SERVICE BULLETIN

Classification: WT10-003c	Reference: NTB10-093c	Date: October 3, 2011
------------------------------	--------------------------	--------------------------

TPMS COMPONENTS NOT INTERCHANGEABLE

APPLIED VEHICLES: 2010 – 2011 370Z Coupe and Roadster (Z34)
2011 cube (Z12)
2011 Juke (F15)
2012 Versa Sedan (N17)

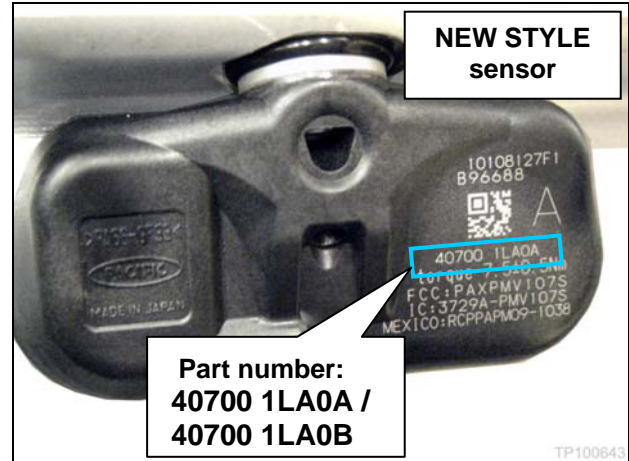
- Nissan now has three different styles of TPMS.
- Components are not compatible and cannot be interchanged between these different styles.
- Swapping of components between these styles will cause the TPMS to stop operating correctly.
- If wheel swaps are done between models with different style TPMS, the original sensors must stay with the vehicle.

2012 Versa Sedan

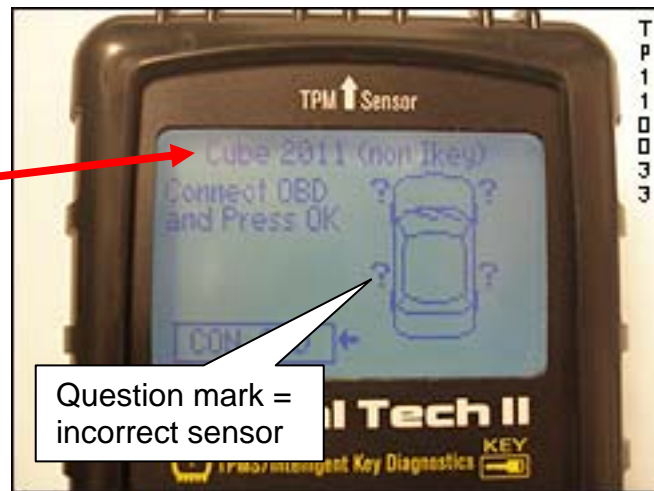
Not interchangeable with Versa Hatchback, Juke or cube.
